SUBJECT: BACKGROUND INFORMATION

SUBJECT: PROBABILITY OF VOLCANISM AT YUCCA MOUNTAIN

SUBJECT: Probability of Volcanism at Yucca Mountain

PROBABILITY OF VOLCANISM AT YUCCA MOUNTAIN

COMPARISON OF VOLCANIC SCENARIOS

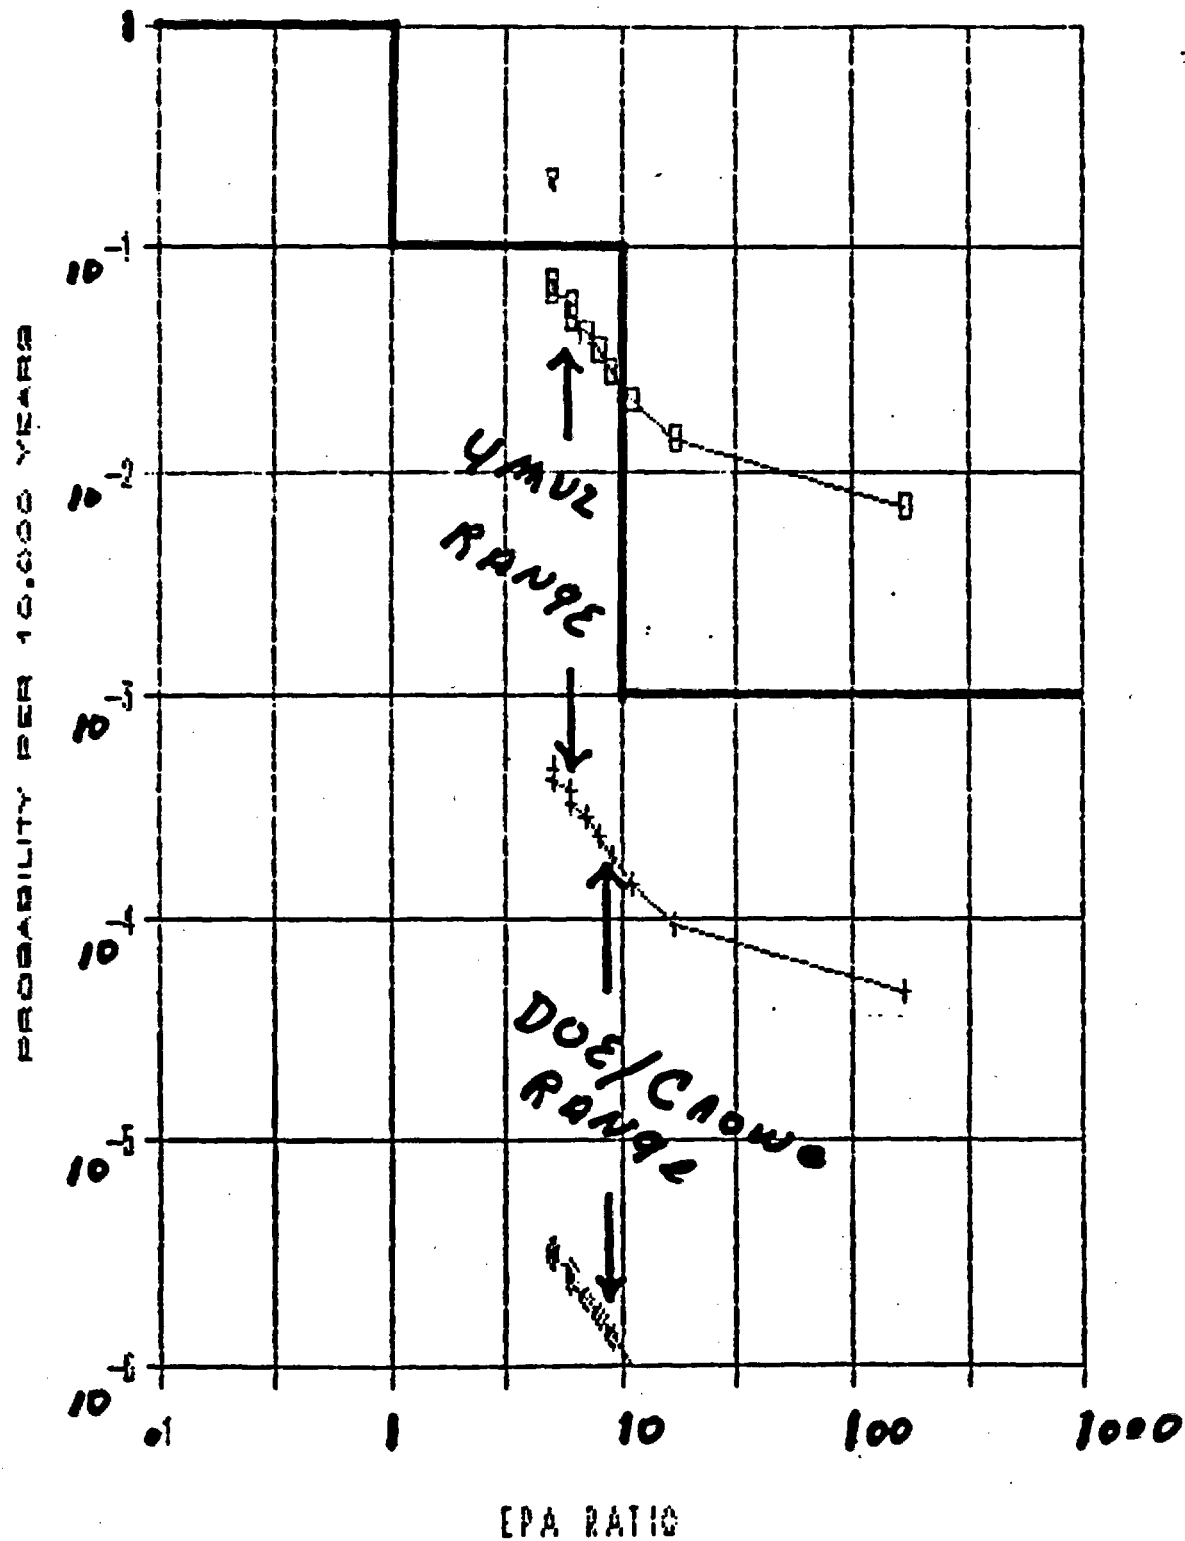
To allow a comparison of the various scenarios discussed in this note I am attaching two drawings showing the interpreted range in effects as would be expressed on a CCDF chart. The fact that this is being expressed as lines, rather than points, is to take into consideration radioactive decay. I have used .1 and .3 percent disruption of the repository for the base cases as these values approximately correspond to the measured sizes of the two plugs. The probability values presented do not consider the potential effects of multiple eruptions or increasing the zone of influence around the site, therefore, I consider the numbers as unconservative. The consequence values also do not cover the full range -- I could come up with more or less in many ways -- but are probably reasonable approximations of expected values. I do consider that this chart represents the problems which would confront the licensing board if this site were to undergo licensing today.

COMPARISON OF VOLCANIC SCENARIOS

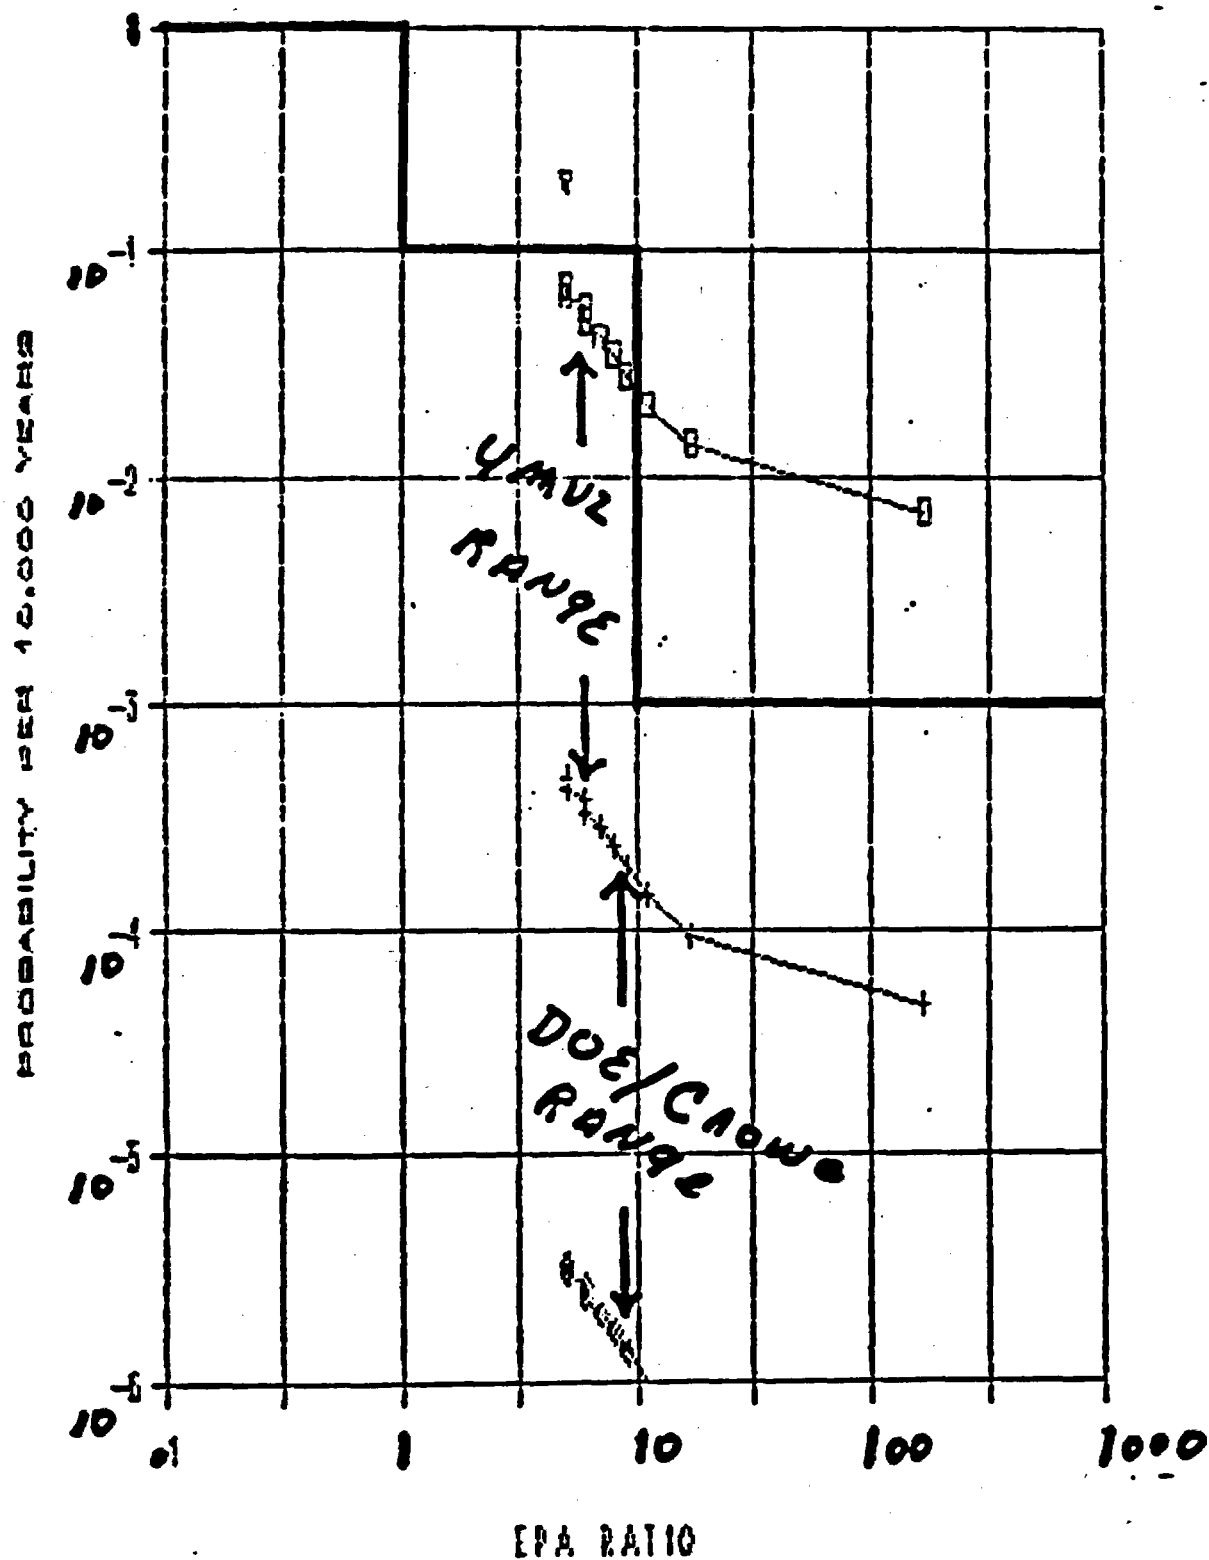
To allow a comparison of the various scenarios discussed in this note I am attaching two drawings showing the interpreted range in effects as would be expressed on a CCDF chart. The fact that this is being expressed as lines, rather than points, is to take into consideration radioactive decay. I have used .1 and .3 percent disruption of the repository for the base cases as these values approximately correspond to the measured sizes of the two plugs. The probability values presented do not consider the potential effects of multiple eruptions or increasing the zone of influence around the site, therefore, I consider the numbers as unconservative. The consequence values also do not cover the full range -- I could come up with more or less in many ways -- but are probably reasonable approximations of expected values.
